DOG RIVER LANDING SUBDIVISION

APPLICATION NUMBER 12 DATE July 24, 2003

REQUEST Subdivision

DOG RIVER LANDING SUBDIVISION

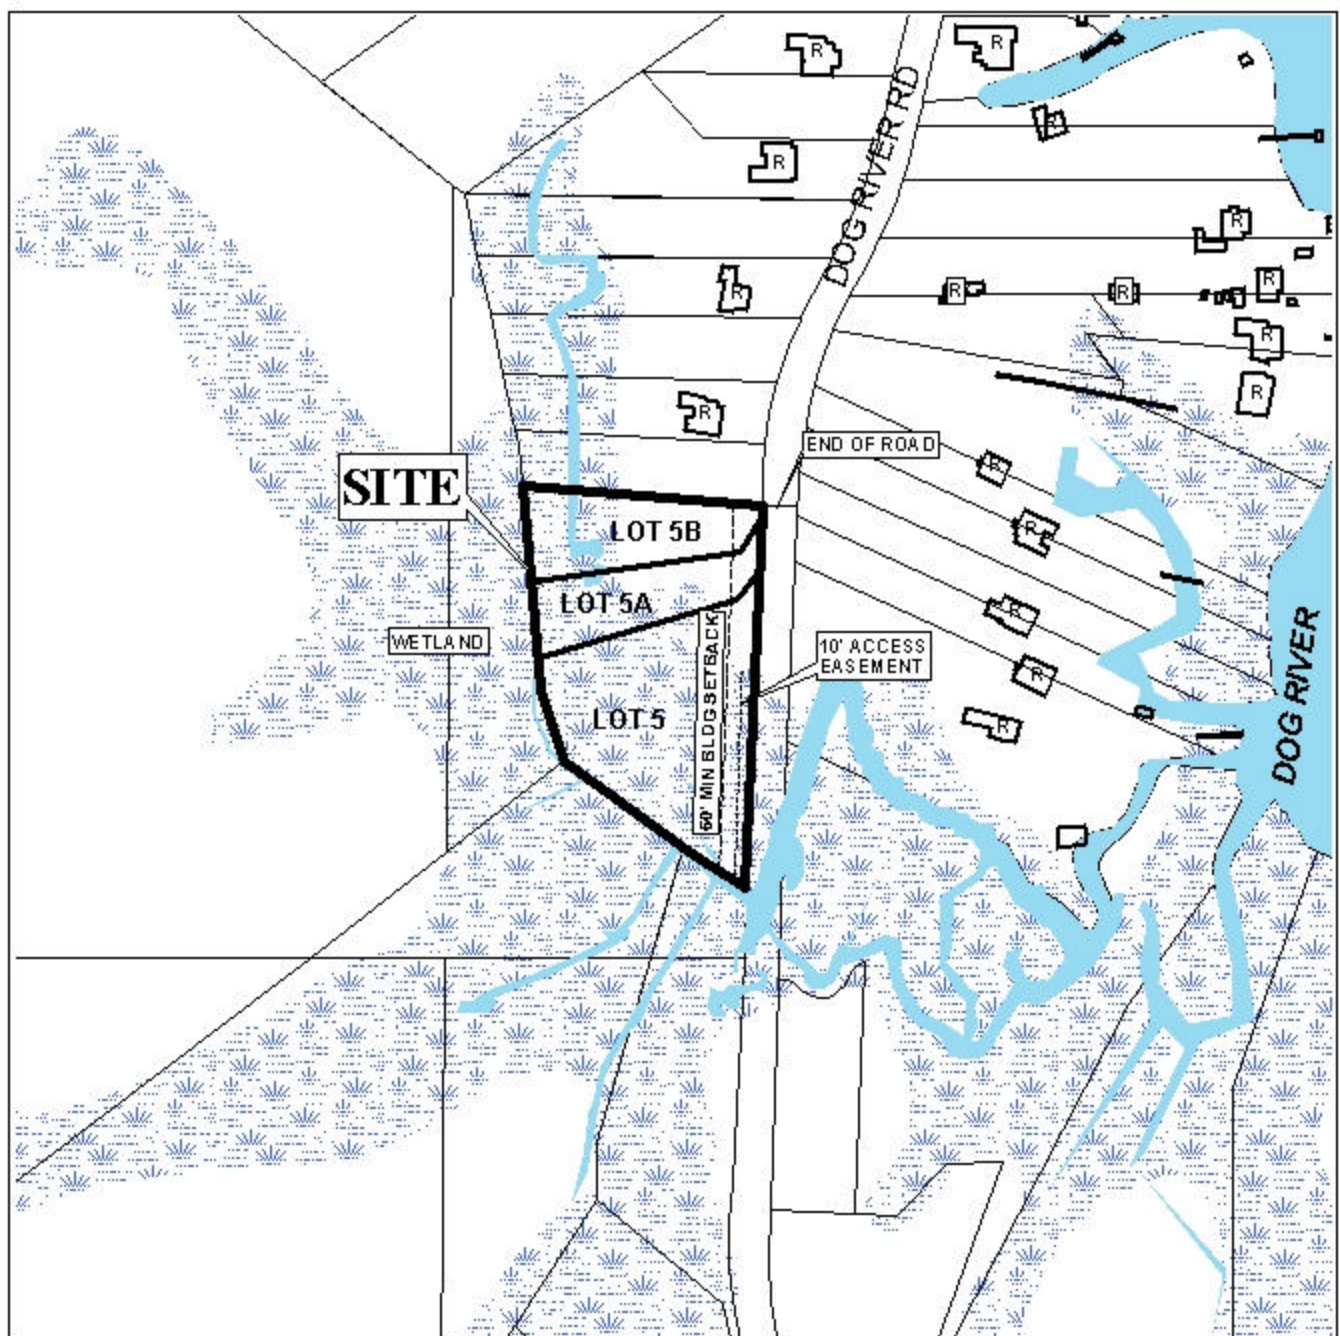
Plat shows a 60-foot setback. Applicant has requested no setback be required. However, the Subdivision Regulations require a 25-foot minimum setback. Additionally, Lots must be 60-feet wide at the setback line.

The placement of a note on the final plat stating that Lot 5 is limited to one curb cut to Dog River Road, with the size, location and design to be approved by the Traffic Engineering Department. Additionally, as Lots 5A and 5B have only 25-feet of street frontage, these lots should be required to share one common curb cut to Dog River Road.

The plat meets the minimum requirements of the Subdivision Regulations and is recommended for Tentative Approval subject to the following conditions: 1) the placement of a note on the final plat stating that construction of Dog River Road to provide access to all Lots and provision of a cul-de-sac (modified), with the design to be approved by the County Engineering Department; 2) the developer to obtain the necessary approvals from federal, state and local agencies prior to the issuance of any permits; 3) the placement of the 25-foot minimum setback line on the final plat therefore, Lots must be 60-feet wide at setback line; 4) the placement of a note on the final plat stating that Lot 5 is limited to one curb cut to Dog River Road; and 5) the placement of a note on the final plat stating that Lots 5A and 5B are required to share one common curb cut to Dog River Road.
